APPENDIX B MITIGATION MONITORING, COMPLIANCE, AND REPORTING PROGRAM REQUESTS AND AUTHORIZATIONS

PUBLIC UTILITIES COMMISSION

Subject: Salt Creek Substation—Review of Minor Project Refinement Request #1

SDG&E's Proposed Minor Project Refinement #1

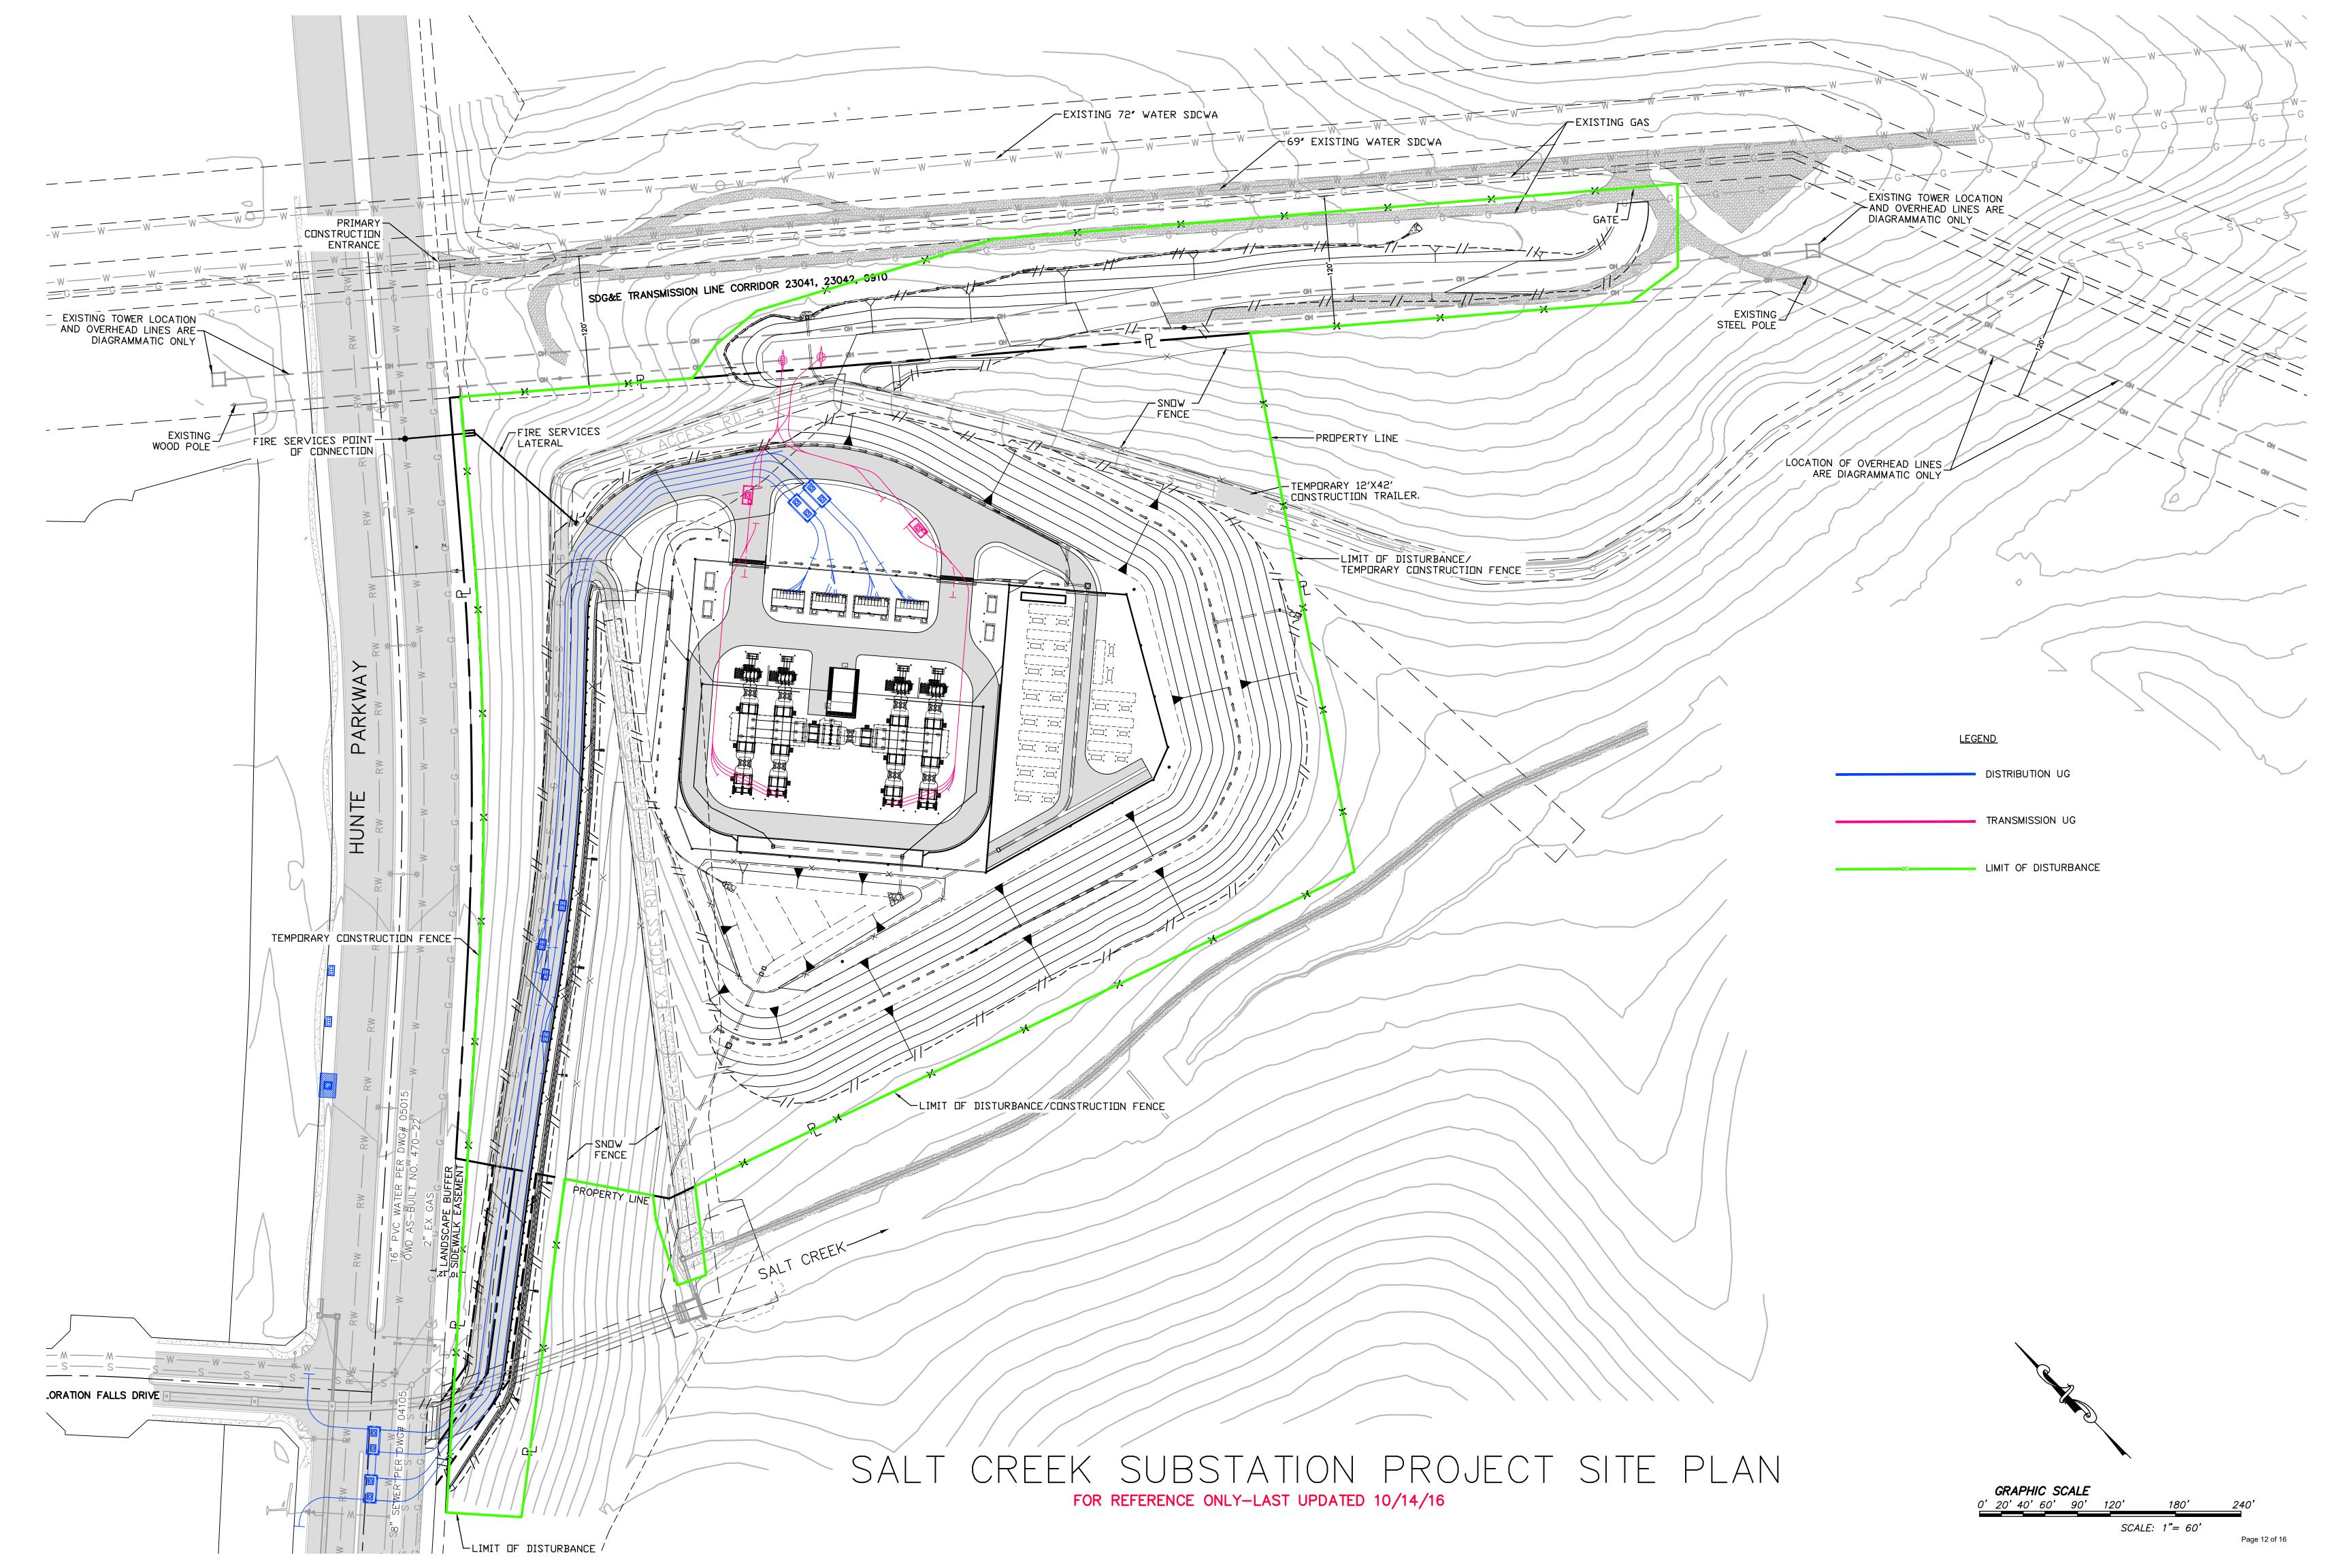
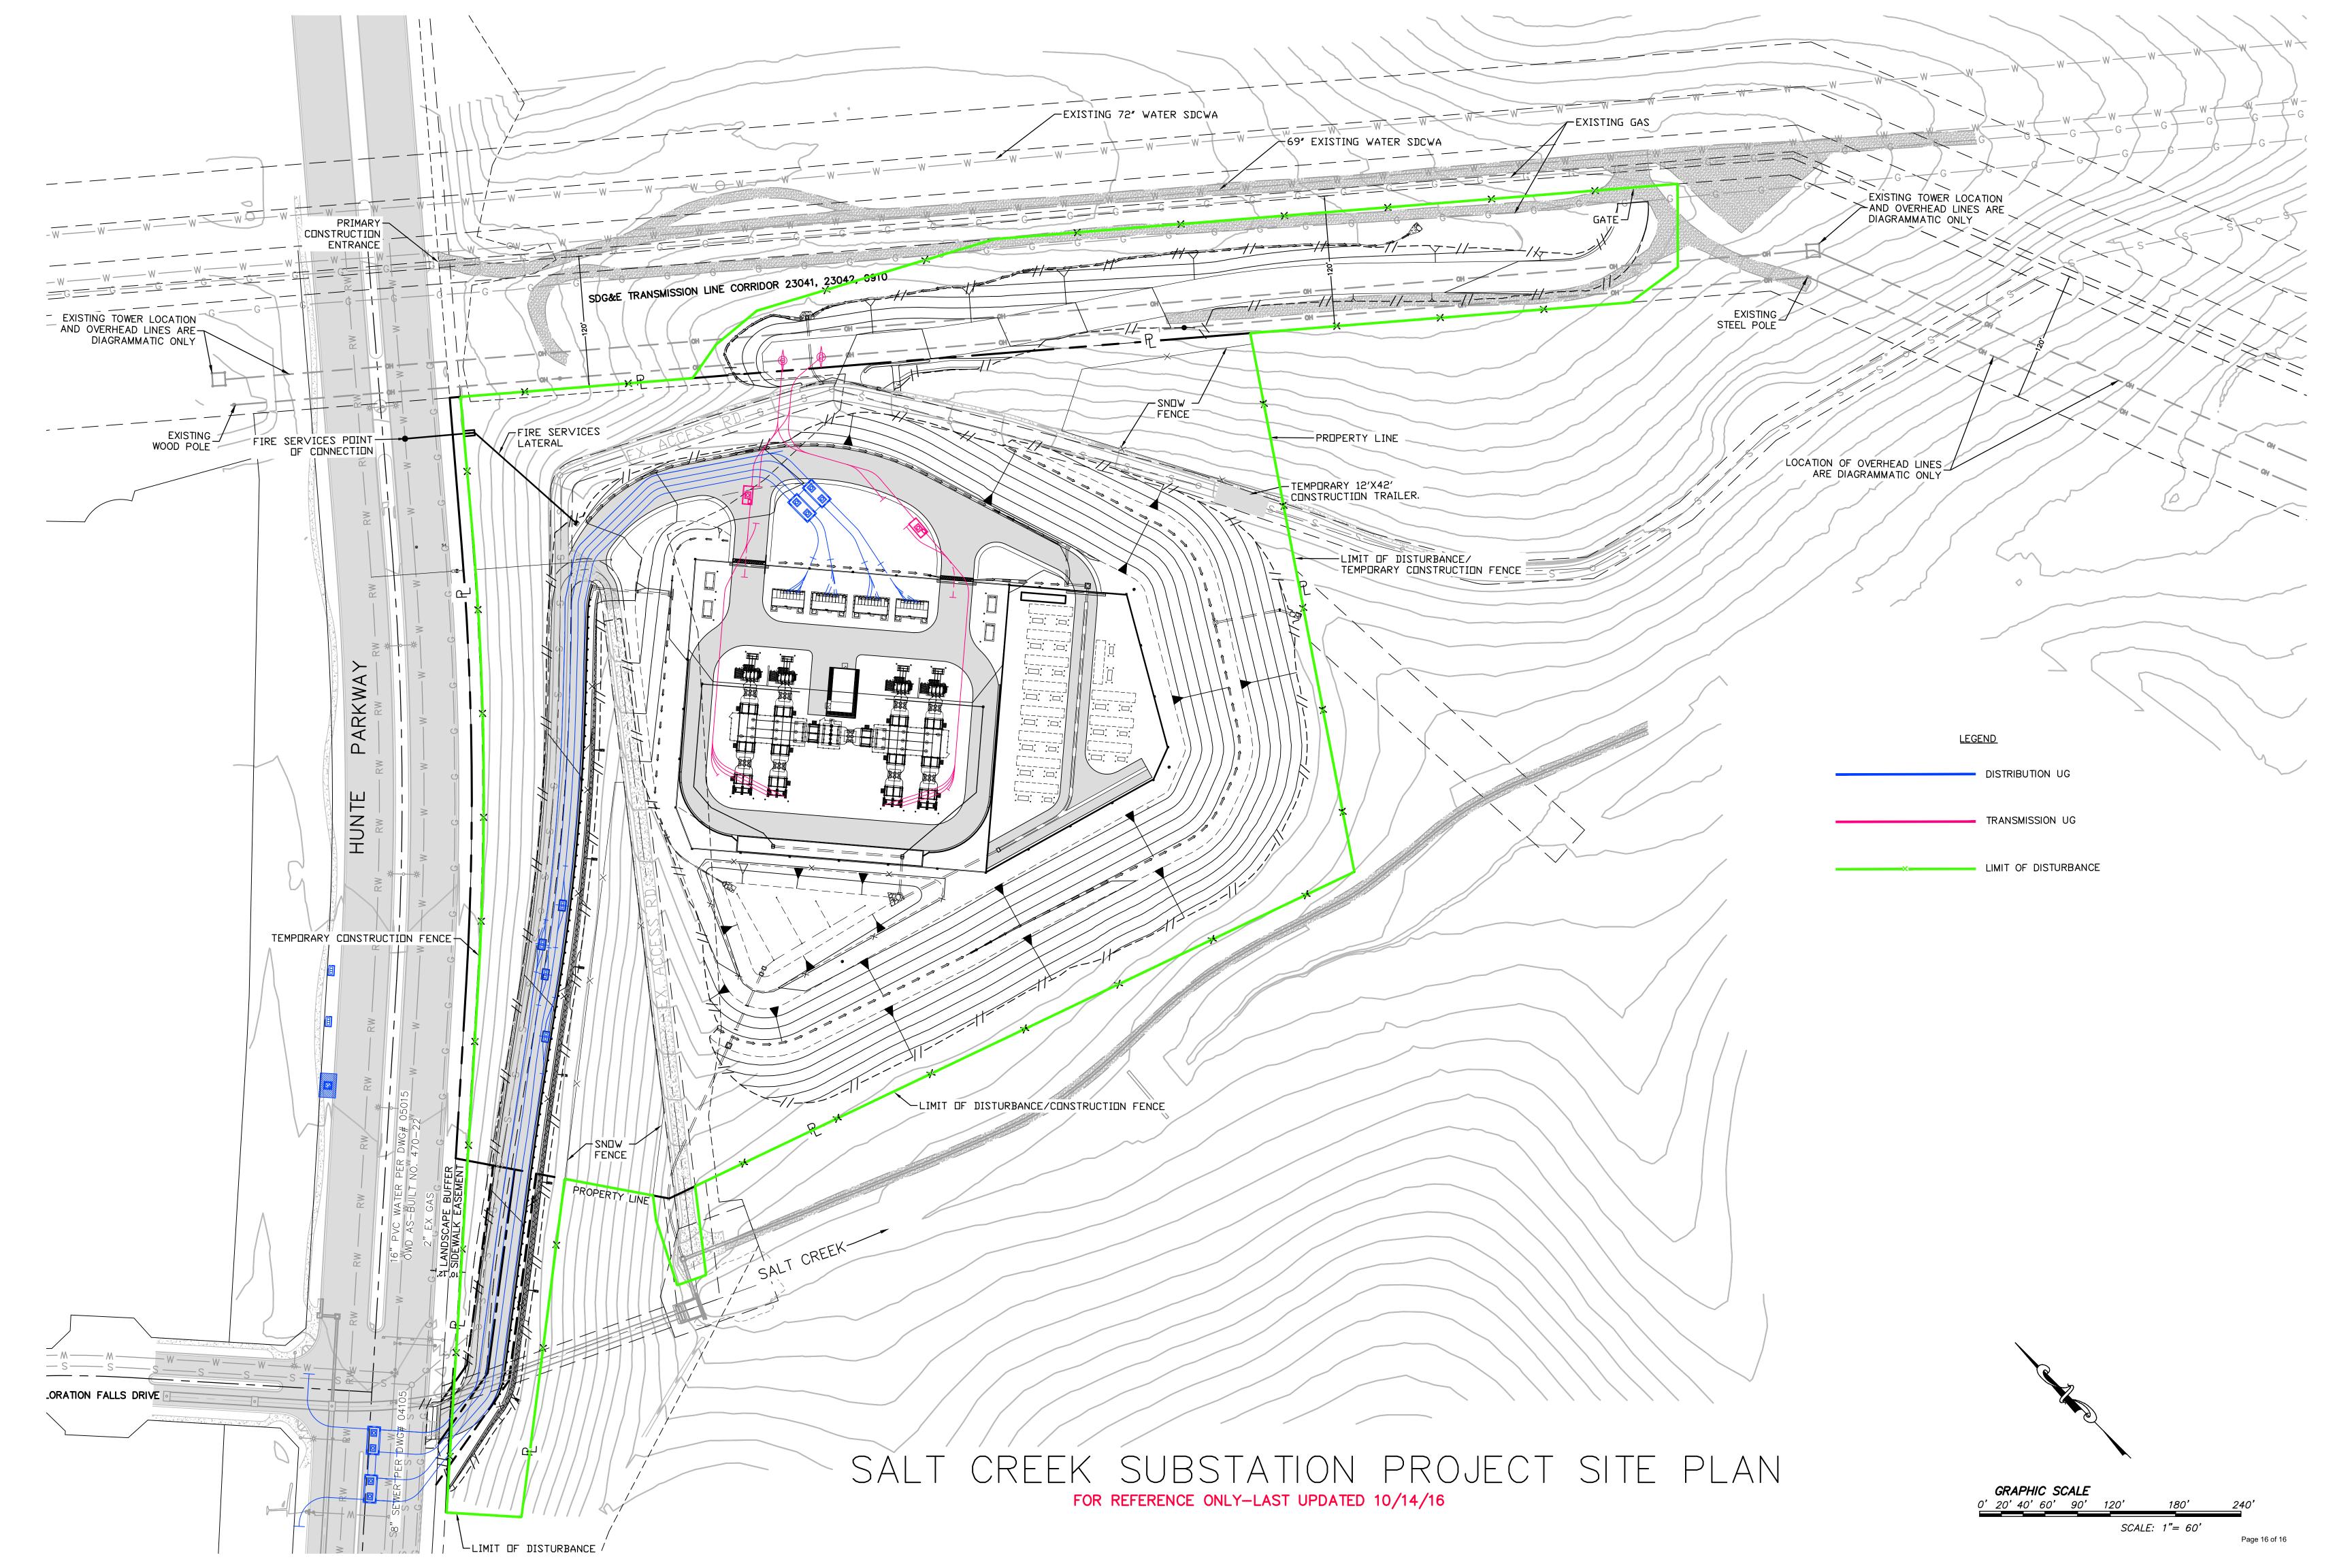
Change of location approximately 100 feet northeast of the fire service lateral line approved in MPR #1.

SDG&E's design team is requesting a change associated with the previously approved MPR #1: Revised Minor Project Refinement Request for Change in Disturbance. Specifically, this MPR #5 is a request for approval of a change in location of the fire service lateral line from the location that was approved in MPR #1. The requested approval date of this MPR #5 is October 24, 2016.

The attached figure (Attachment 1) shows the new location of the fire service lateral line.
